Re: Response to Request for Additional Information, Project Plans and Risk-Based AoR,
Carbon TerraVault Holdings LLC (CTV) VI Project
Underground Injection Control (UIC) Permit Application
Class VI Pre-Construction Permit Application No. R9UIC-CA6-FY24-2.1 to 2.7

Carbon TerraVault Holdings LLC (CTV) has prepared this response to the U.S. Environmental Protection Agency Region IX ("EPA") CTV VI Class VI Permit Application request for additional information dated August 21, 2025 and October 27, 2025. Responses to each EPA comment are attached to this letter. The following permit application components have also been revised in response to EPA comments:

RTC Figure 1: Pseudo leakage source location, existing monitoring well locations and proposed CO₂ injectors. Figure added in response to EPA question #17.

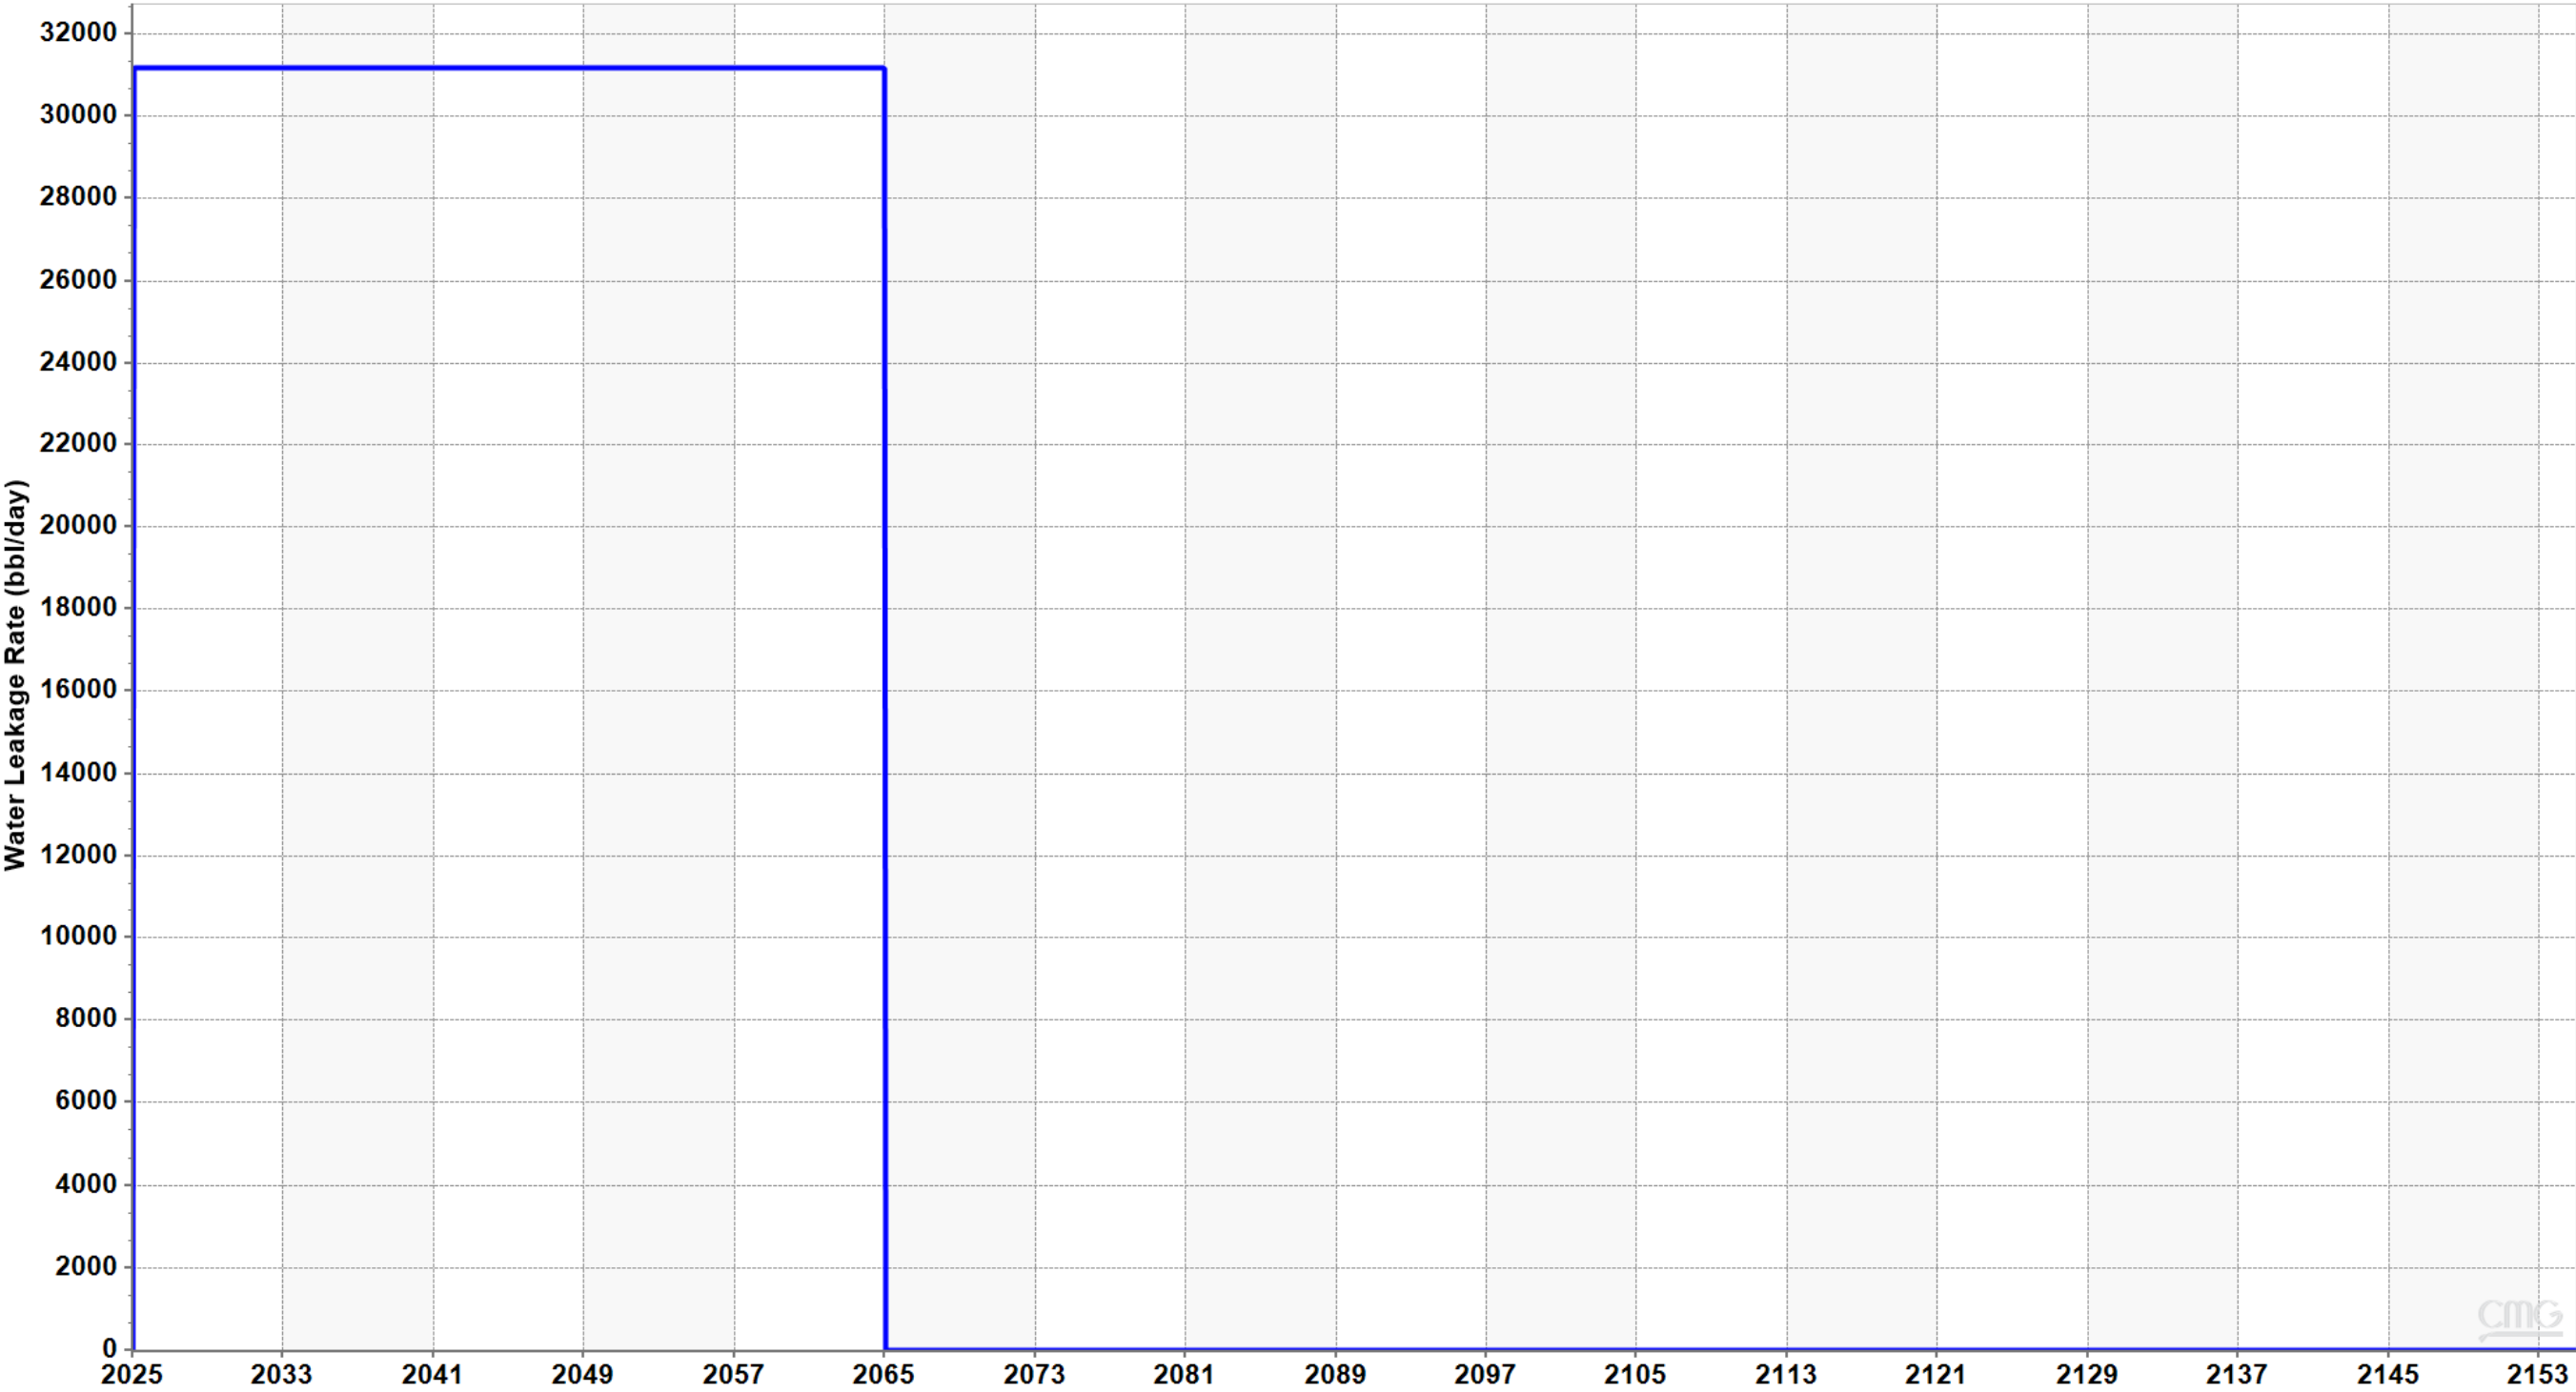
16	The corrosion coupon materials will need to be incorporated into the final T&M Plan.	None	Acknowledged.
Above Confining Zone Monitoring	17	Spatial coverage is lacking in the northwest and southeast portions of the AoR. Please describe how the proposed monitoring well locations would detect any CO ₂ leakage above the confining zone in the northwestern and southeastern portions of the AoR, or otherwise if additional monitoring wells are required for adequate spatial coverage.	None	<p>A dynamic model that includes the Zilch and Kreyenhagen formations was developed to show how the proposed monitoring well locations are capable of detecting leakage above the confining zone in the northwestern and southeastern portions of the AoR. RTC Figure 1 located at the bottom of this matrix displays a hypothetical leakage location (pseudo leakage source location) southeast of the plume boundary.</p> <p>A conservative hypothetical leak of 0.1% of the total storage volume was simulated from the injection zone into the Zilch over a period of 40 years. RTC Figure 2 illustrates the leakage rate versus time, and RTC Figure 3 displays the recorded pressure increase within the Zilch at the existing monitoring wells. RTC Figure 4 displays the pressure increase radius (4 psi limit) from the pseudo leakage location at one year within the Zilch formation. Lastly, RTC Figure 5 overlays the pressure radius (26,300 feet) to the existing monitoring well locations to illustrate the total spatial area covered by the monitoring well locations.</p> <p>These results indicate that the existing monitoring well locations are adequate in detecting a minor leakage of fluid and resulting pressure change above the confining zone, within, and beyond the AoR. Identifying a pressure change within the Zilch is the optimal approach for detecting a leakage of water or CO₂ above the Confining Zone. Direct detection of CO₂ would necessitate a virtually infinite array of monitoring wells, as hypothetical leakage pathways could occur at any arbitrary location.</p>
